Work Order ID 78859

Item Name: Crosstube Fwd

DRAWING NO. D206-667-141	TITLE CROSSTUBE ASS'Y (206B HIGH FWD)	REV. C	DART AEROSPACE LTD ENGINEERING ORDER		D.E.O. NO. D206-667-141-C-1	SHEET NO. SHEET 1 OF 1	SCALE NTS
DRAWN P	CHECKED ASS	MFG. APPR. [Signature]	APPROVED [Signature]		DE APPR. [Signature]		
DATE 11.07.15	DATE 11.07.20	DATE 11.07.21	DATE 11/07/21		DATE 11.07.21

DART SERVICE INSTRUCTION

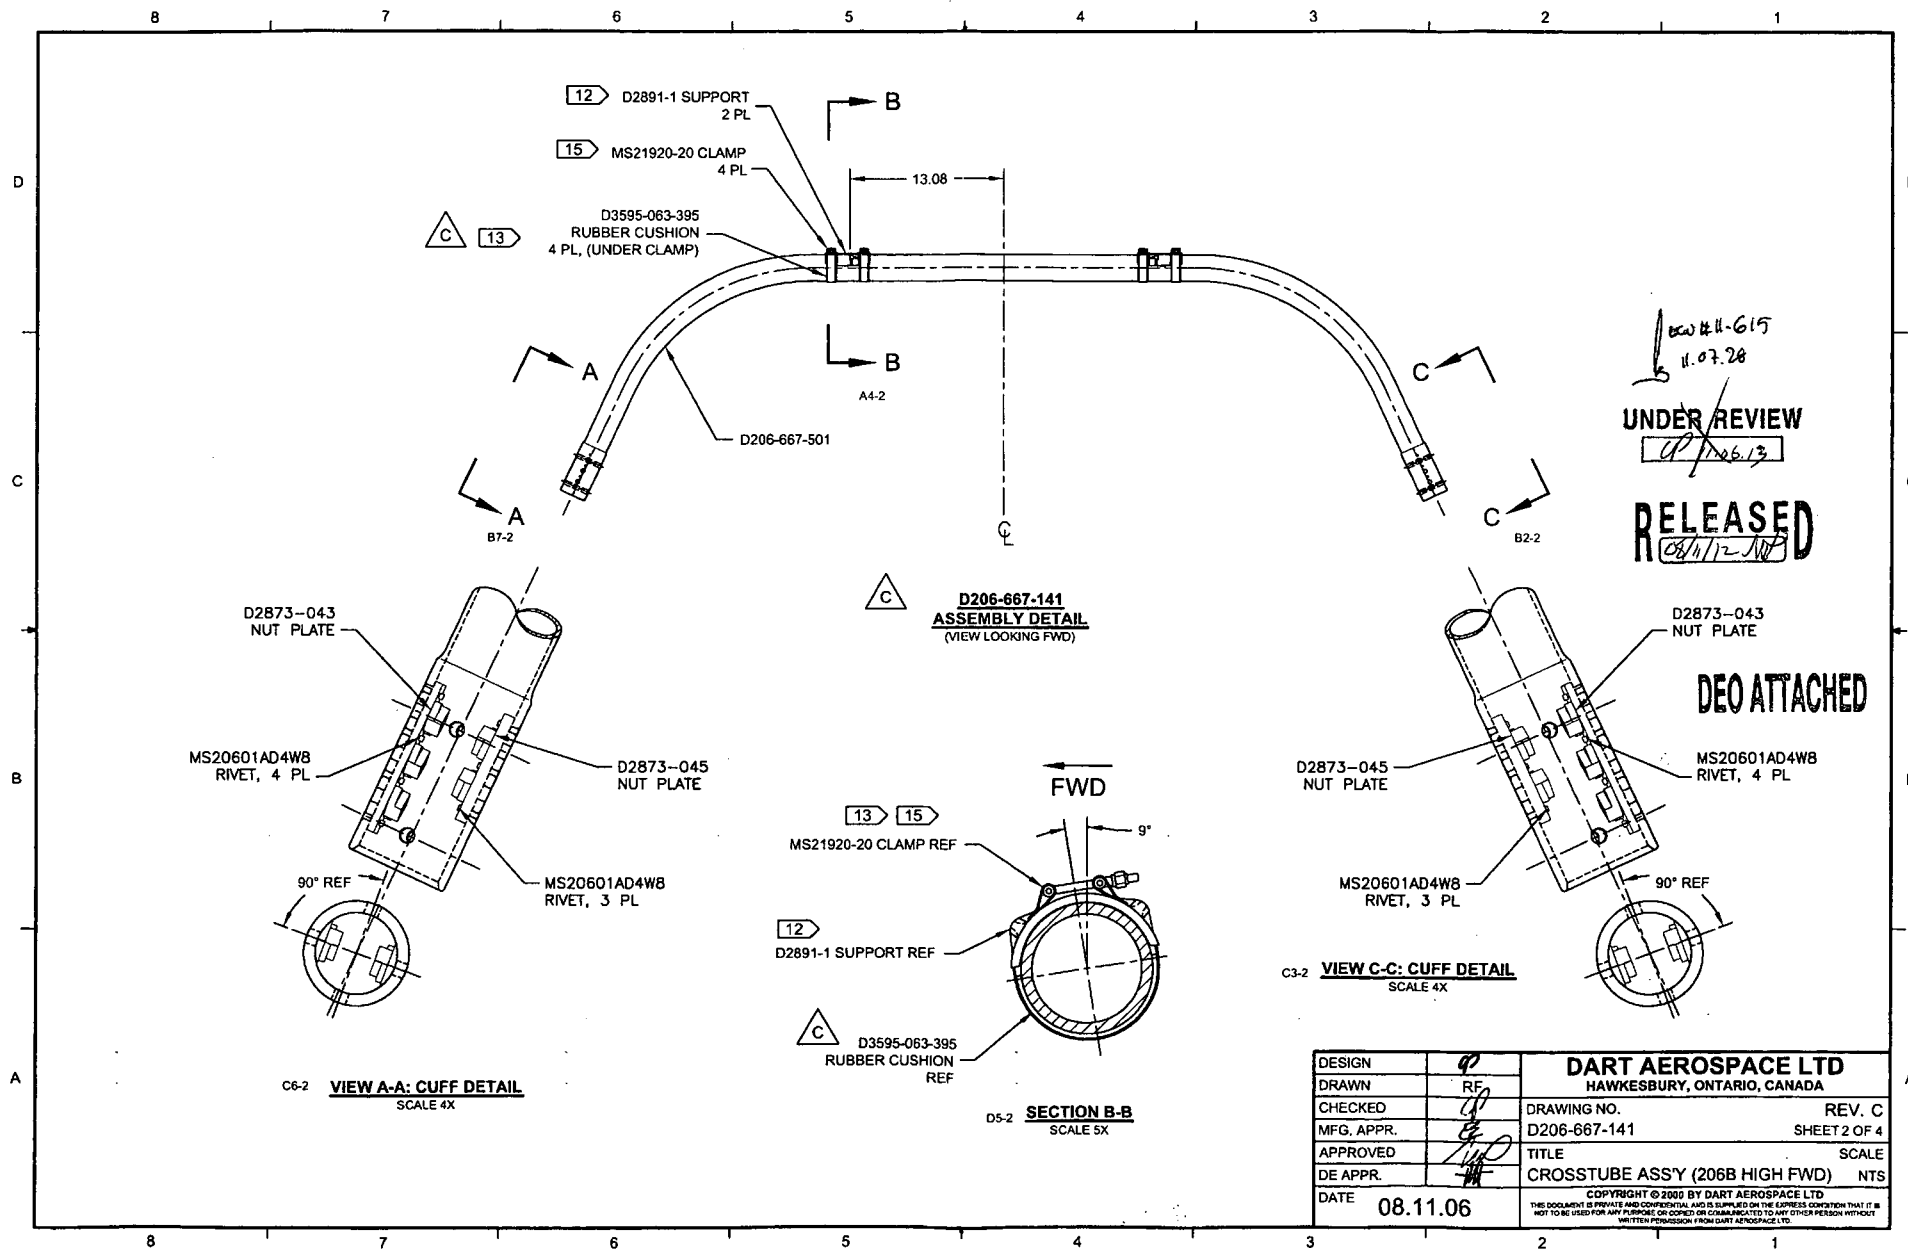
C	REVISE GENERAL NOTES/PART LIST (ZN D7-1); REORGANIZED VIEWS AND REFORMATTED DRAWING TO CURRENT STANDARDS. D3595-063-395 WAS D2856-400-694 (ZN D6-2 & A5-2); REMOVED REF. & ADD TOLERANCES (ZN C4-3, C5-3 & D3-3); RELOCATED FLAG #6 (ZN A8-3) PER NCR 210; MOVED TURNING DETAIL & UPDATED TOLERANCE TO SHEET 4.	RF	08.11.06
B	ADD HOLES AND NUT PLATES FOR COMPATABILITY WITH BHT/AA SKUDTUBES	PH	05.07.26
A	NEW ISSUE	CP	00.11.17
REV.	DESCRIPTION	BY	DATE
DESIGN	RF	DART AEROSPACE LTD HAWKESBURY, ONTARIO, CANADA	
DRAWN	RF	DRAWING NO. D206-667-141	
CHECKED	RF	REV. C	
MFG. APPR.	RF	SHEET 1 OF 4	
APPROVED	RF	TITLE	
DE APPR.	RF	CROSSTUBE ASS'Y (206B HIGH FWD) NTS	
DATE	08.11.06	COPYRIGHT © 2000 BY DART AEROSPACE LTD THIS DOCUMENT IS PRIVATE AND CONFIDENTIAL AND IS SUPPLIED ON THE EXPRESS CONDITION THAT IT IS NOT TO BE USED FOR ANY PURPOSE OR COPIED OR COMMUNICATED TO ANY OTHER PERSON WITHOUT WRITTEN PERMISSION FROM DART AEROSPACE LTD.
